CITY OF FRANKLIN
PLAN COMMISSION MEETING*
FRANKLIN CITY HALL COUNCIL CHAMBERS
9229 W. LOOMIS ROAD, FRANKLIN, WISCONSIN
AGENDA
THURSDAY, DECEMBER 17, 2020, 7:00 P.M.

Project Name:	Strauss Site Plan Amendment – Parking Lot
Project Address:	9775 S 60th Street
Applicant:	Strauss Investments LLC
Property Owner:	Strauss Investments LLC
Current Zoning:	M-1 Limited Industrial District
Use of Surrounding Properties:	P-1 Parkland Parkway to the south and west, and M-1 Limited Industrial to the north and east
Applicant’s Action Requested:	Approval of Site Plan Amendment

Date: November 24, 2020
PEG: December 3, 2020 - PEG Comment Response
To: Strauss Investments LLC
From: Department of City Development
RE: Strauss Investments LLC - 9775 S 60th St. - Site Plan Amendment – Staff
Comments

FRANKLIN DEVELOPMENT - NATURAL RESOURCES PROTECTION PLAN

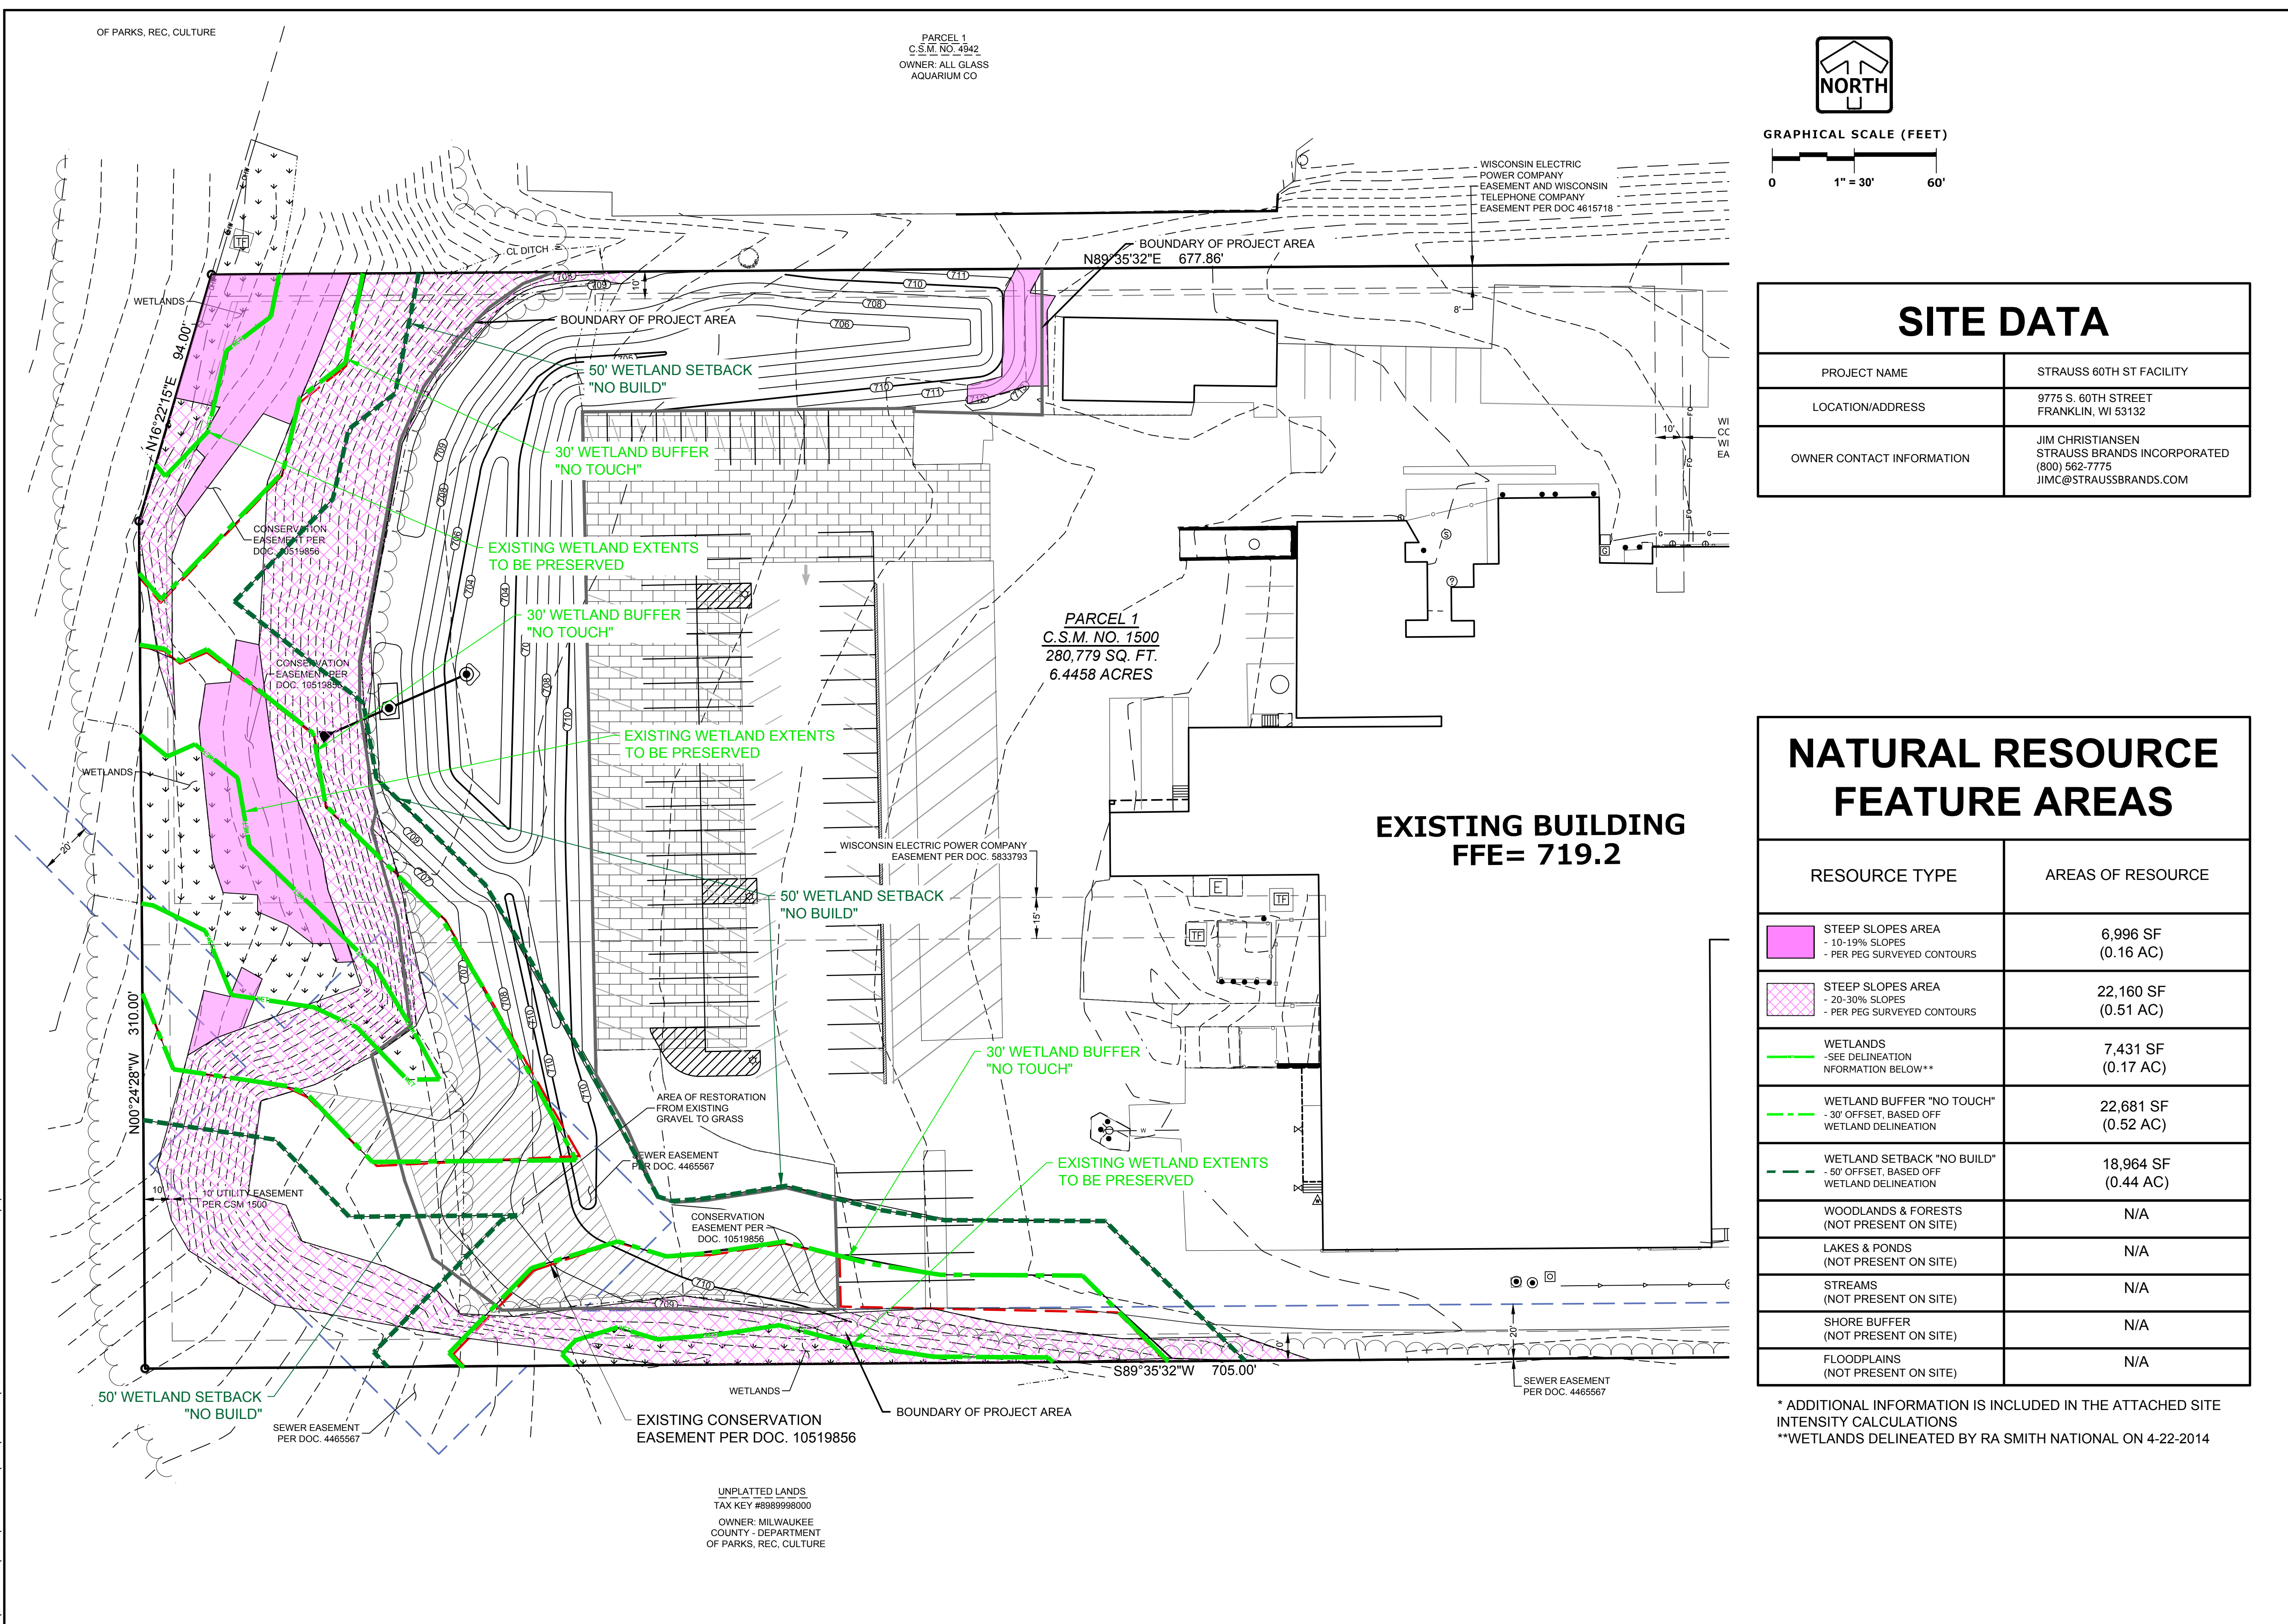
9. Please include the following information on the Natural Resource Protection Plan for this project, as required by §15-7.0201:
 - a. Name of the project (§15-7.0201A);

- g. Please show the conservation easement boundary on the NRPP (§15-7.0201K).
 - i. PEG 12/3/20: All requested elements have been added to the NRPP Exhibit.

- a. PEG 12/3/20: A sign has been added in the southwest portion of the site that will indicate the presence of conservation areas.
16. Staff suggests depicting the boundary of the project area on the NRPP.

- a. PEG 12/3/20: Project Area has been added to the NRPP.
17. Please indicate the areas of restoration on the NRPP.
PEG 12/3/20: Restoration Areas have been added to the NRPP

SITE DIMENSION & PAVING PLAN

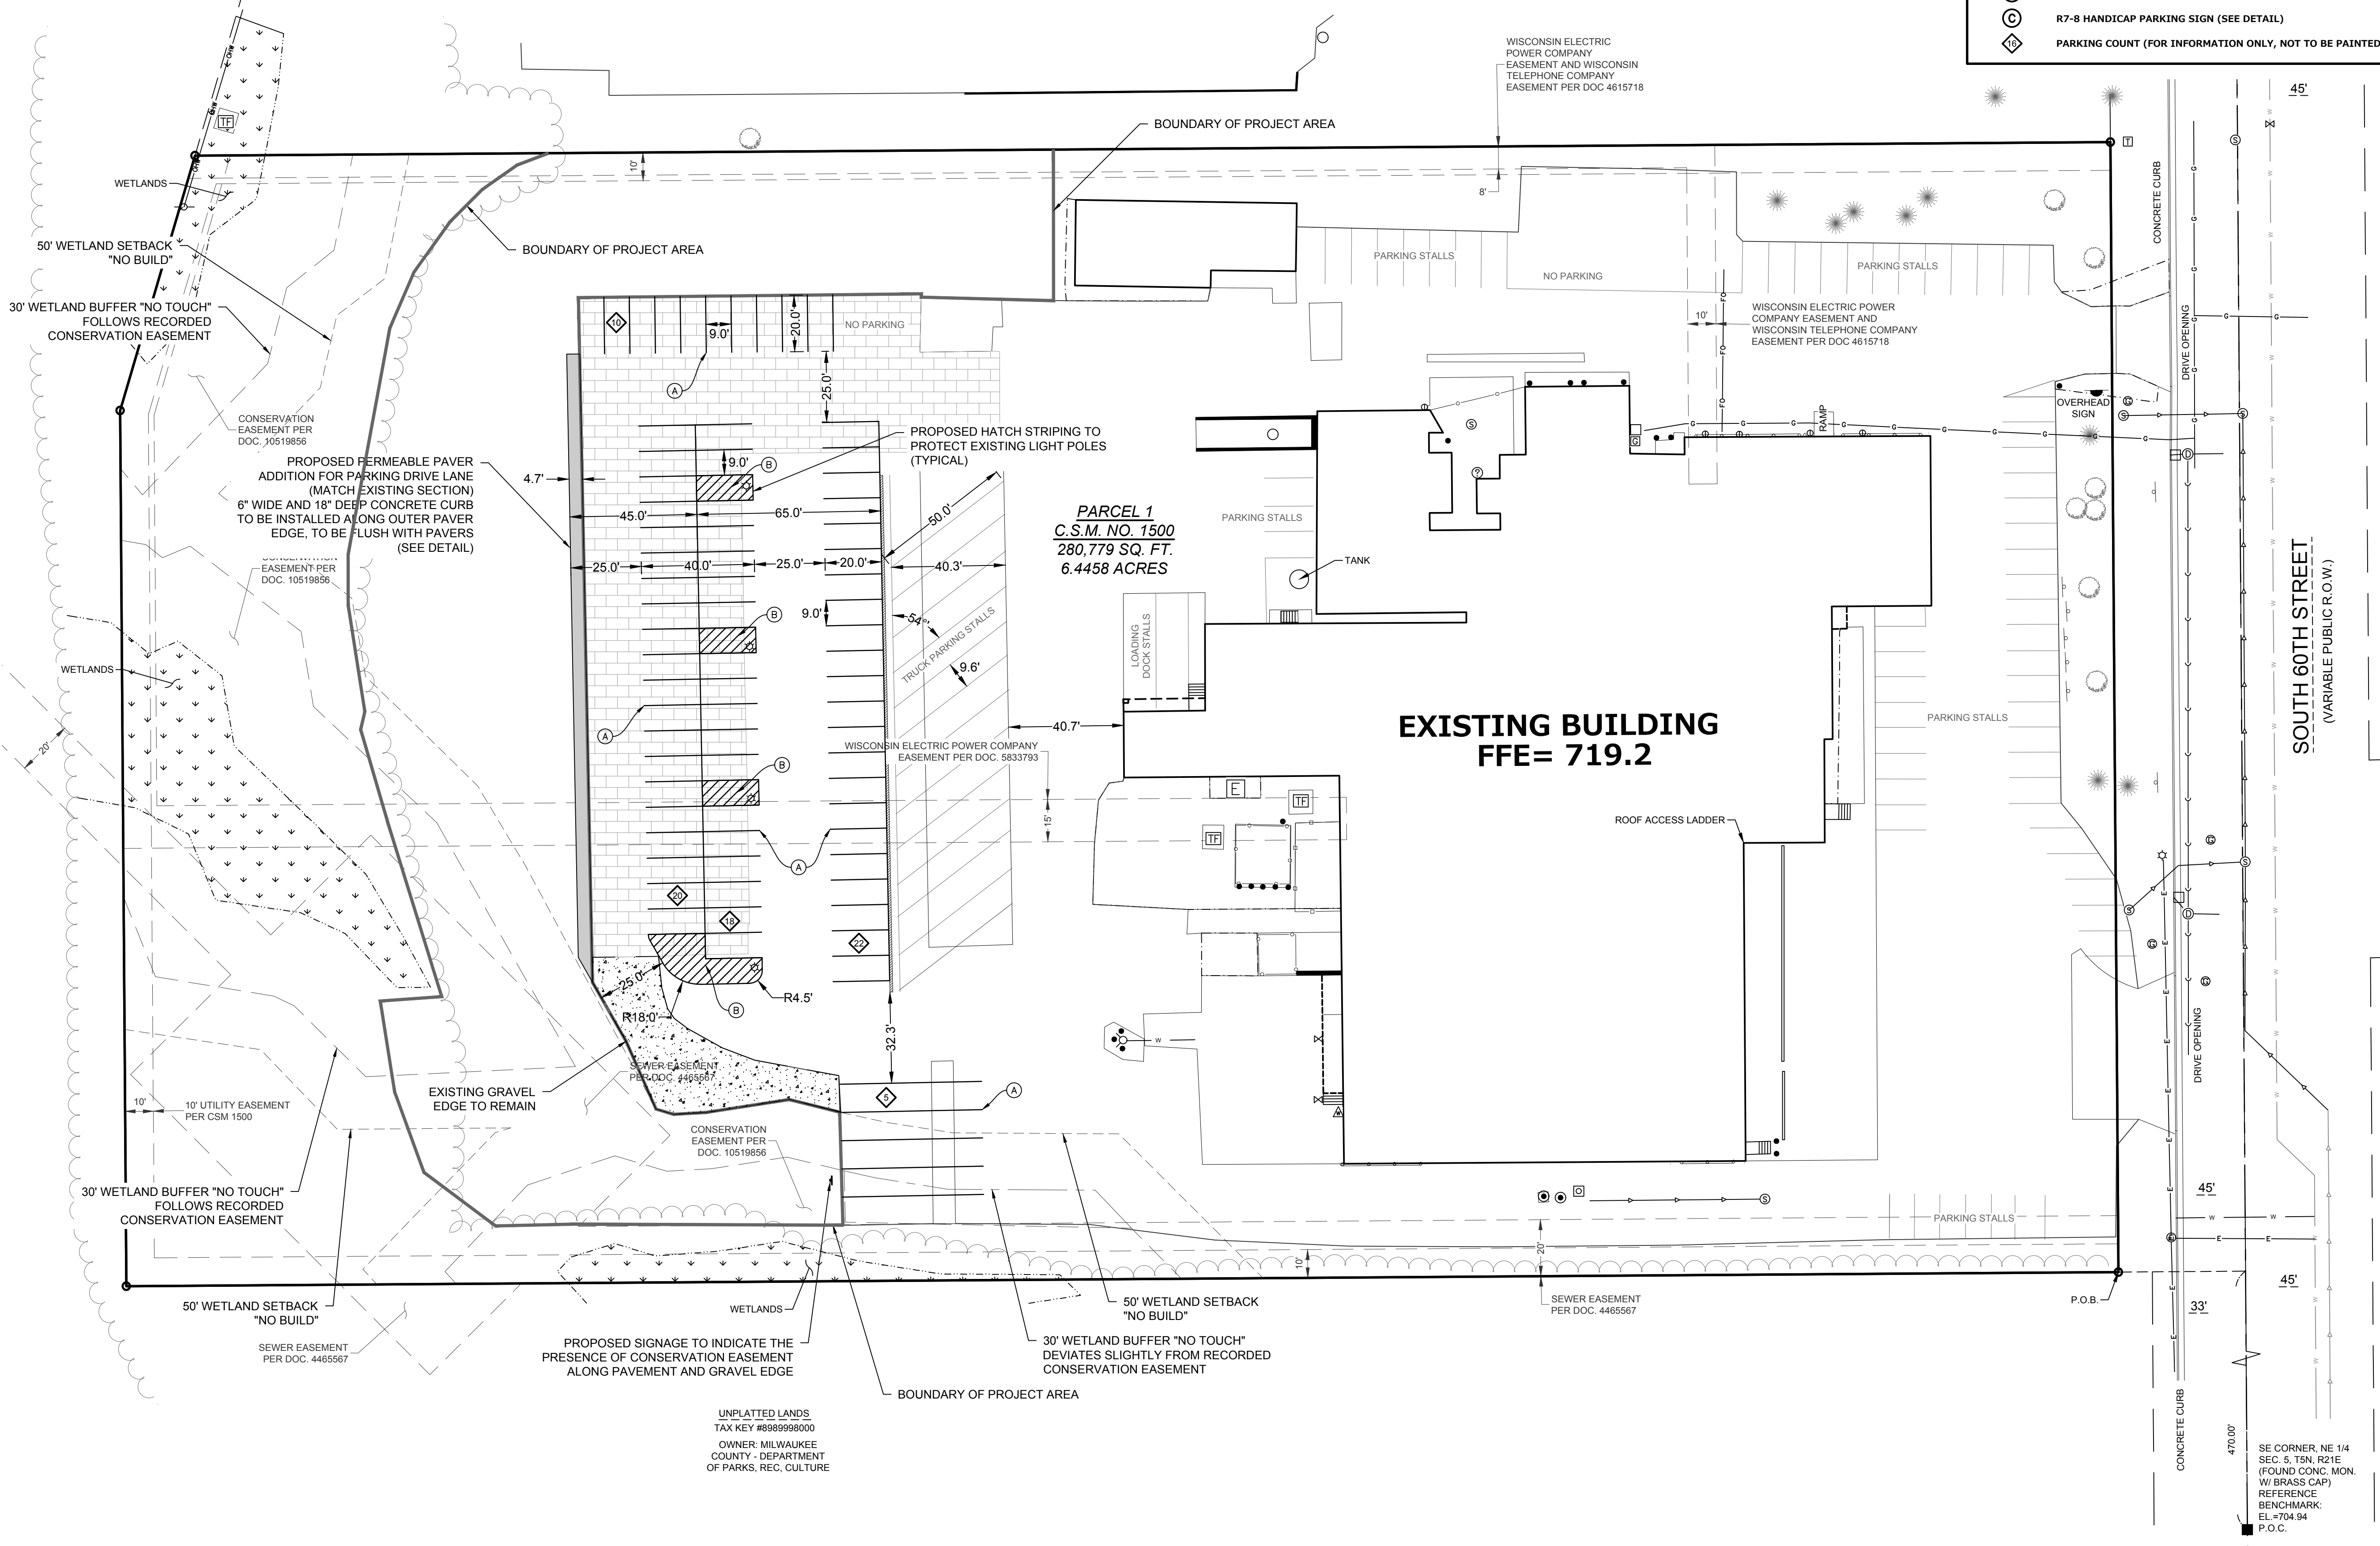
- b. §15-5.0202E requires installation of concrete curb and gutters for parking lots. Plan Commission may waive this requirement when "located in areas without a predominance of curb and gutter." If the proposed paving meets this standard, please request the waiver in revised materials.

- i. PEG 12/3/20: A waiver for this requirement will be pursued due to the absence of curb and gutter on the majority of the rest of the site.
 - c. Please revise aisle dimensions to meet the standards of §15-5.0204A

12. Staff suggests depicting the boundary of the project area on the site plan.
 - a. PEG 12/3/20: A current project area boundary line has been added to the site plan.
